AGENDA
SUTTONS BAY TOWNSHIP PLANNING COMMISSION
SPECIAL MEETING

Special Meeting of the Suttons Bay Township Planning Commission called for the purpose of continuing the review and consideration of the proposed Cherry Beach Orchards Open Space Residential Development.

Update on Application for Site Plan Review & Open Space Development Cherry Beach Orchards – Mark & Karen Drake Property, 855 S. Stony Point Rd. – Property No. 45-011-027-039-00

06/03/2025 (prepared by ZA)
(Response by Applicant 06/17/25)

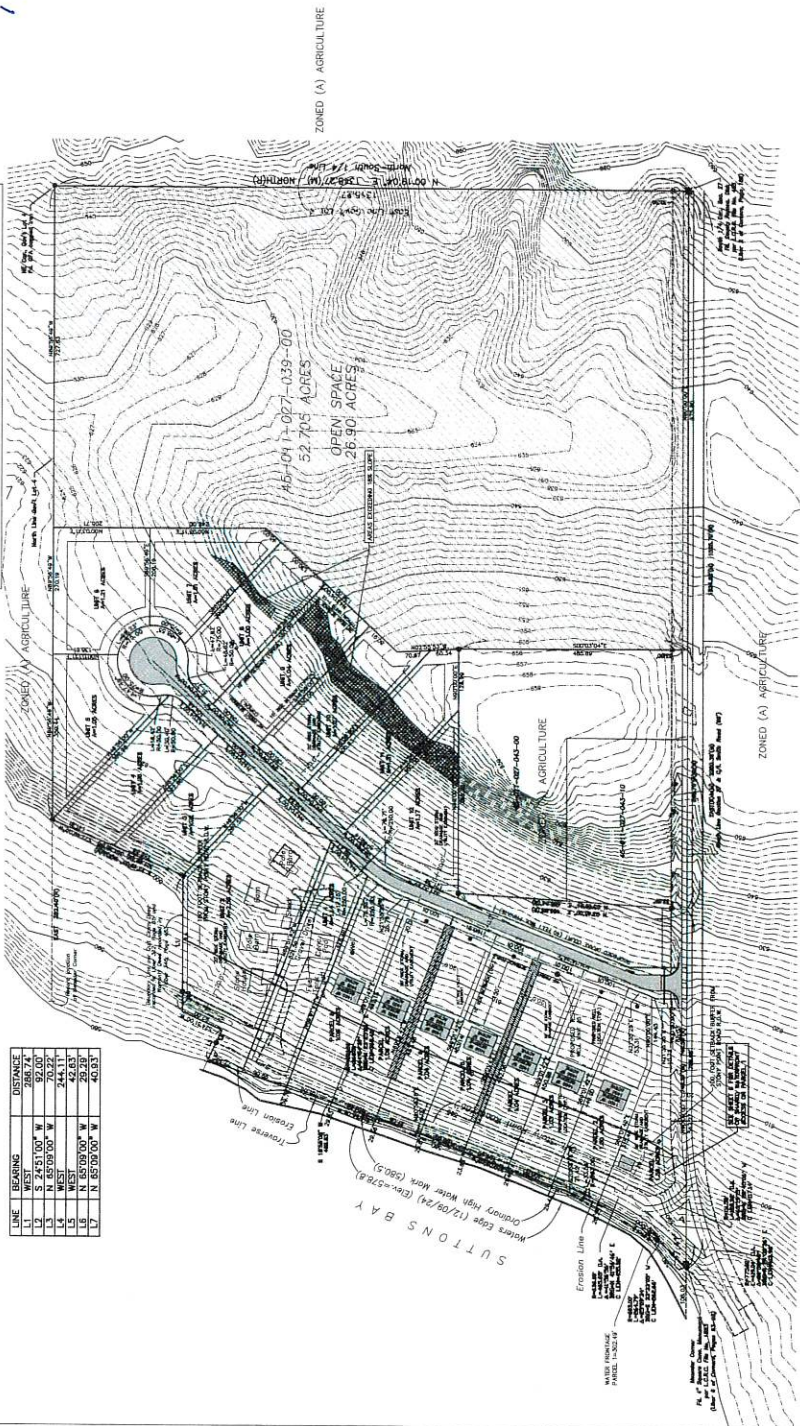
- 1) As requested in the June, 3rd, 2025 planning commission meeting, attached is a site plan revision showing the 100' buffer from Stony Point Rd. and the 18% slope areas on the property. The planning commission did not require a full size set of plans for these changes, just an 8.5 x 11 copy.
- 2) Scenic vistas and scenic view lines document (as presented in the June 3rd, 2025 meeting)
- 3) Outstanding items checklist from the June 3rd, 2025 meeting
- 4) View shed analysis (TK Design) - There are 3 different views that incorporate the size and elevations of the proposed homes on the property.

- *Provided by Applicant from Engineer and O'nan Surveying, April, 2025*
- Show areas with 18% slope. (per the ordinance)
 - *See attached Site Plan, Revised 06/18/25*

- Section 16.4.A.1.a The Ownership of the "Open Space" will remain with current Owners.
- Show upland buffer described in the ordinance.
 - See attached Site Plan, Revised 06/18/25
- Does PC want full size copies of the Phase I drawing that was handed out by the Applicant on May 7th?
 - No, per 6/03/25 meeting comments, 8.5 x 11 copy attached and electronic copy to ZA.

"A"

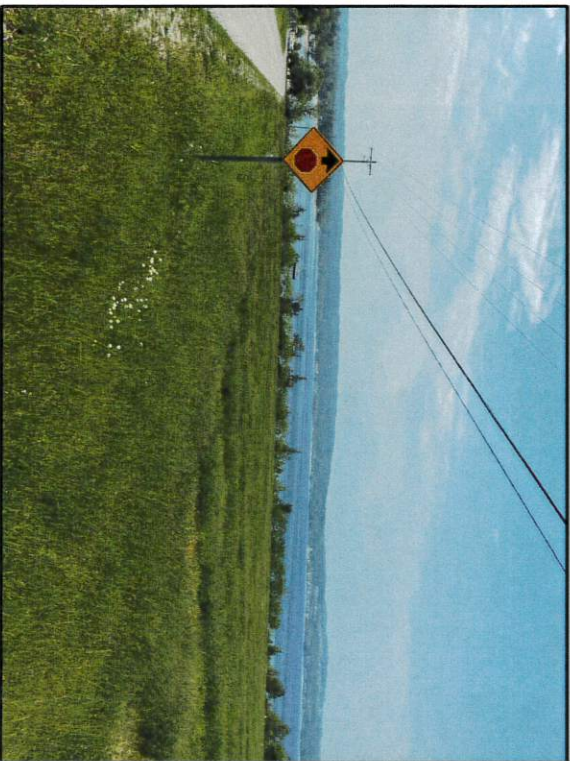
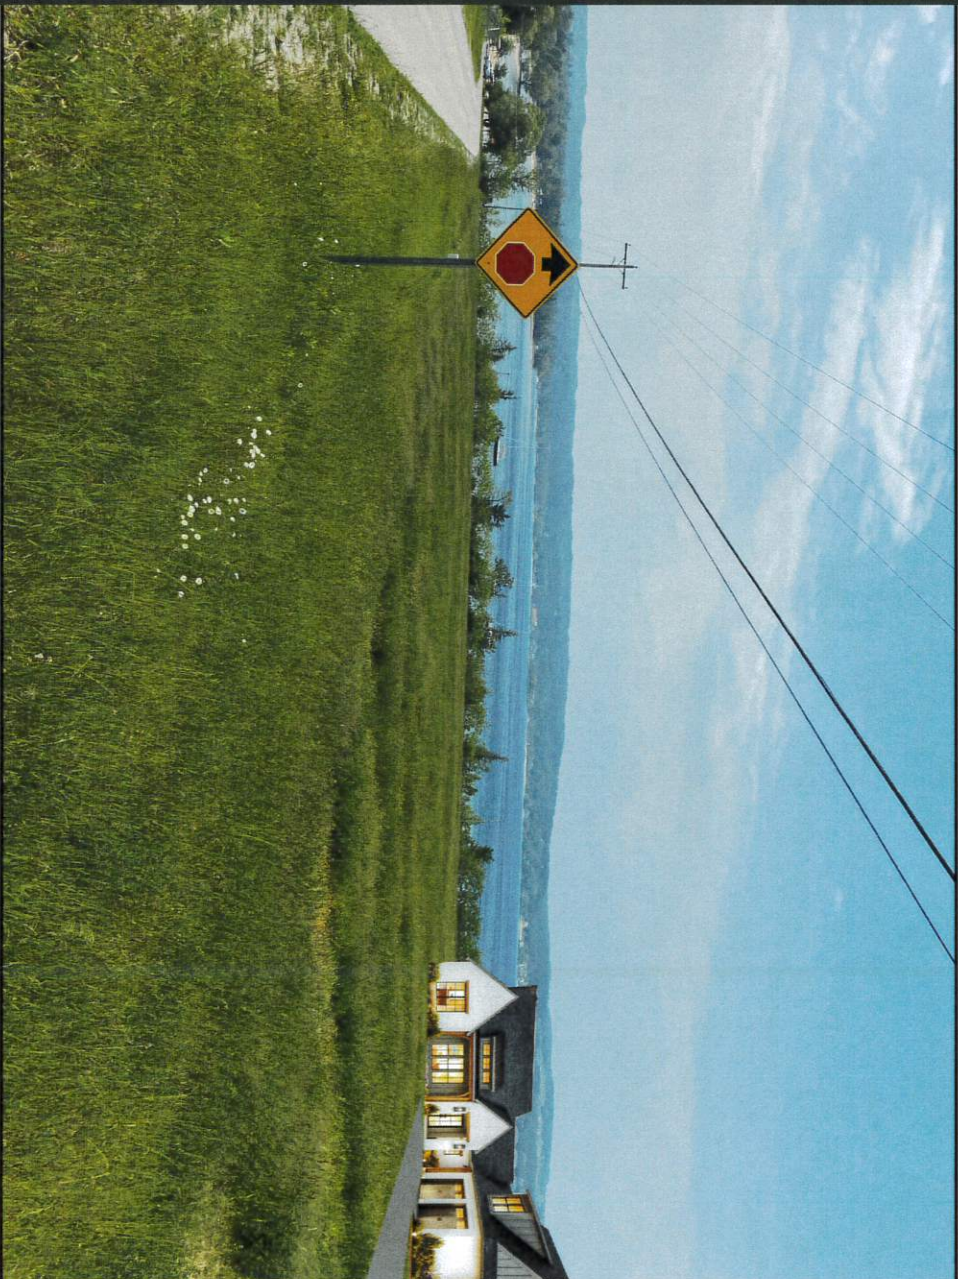
- *ViewShed Analysis, Section 16.7.B.6, provided June 19, 2025 (See attached)*
- Description of the proposed Open Space conveyance, ownership, and allowable uses/ restrictions. (per the ordinance)

- As discussed by several commissioners last night, a viewshed analysis is required by Section 16.7. B. 6 and would be very helpful for the Planning Commission and the community to understand the visual impact of this development fully. However, since Steve Morgan stated that he did not know exactly what one was or what was required for one, I recommend that the Planning Commission provide specific requirements to him so that he knows exactly what is required. The ordinance states: "Scenic views onto the tract or parcel from surrounding roads and public areas, as well as views of scenic features from within the tract." It's entirely up to the **Planning Commission** to specify the requirements for this process. To help, I have conducted research and identified resources that may assist the Planning Commission in determining its requirements for the viewshed analysis.
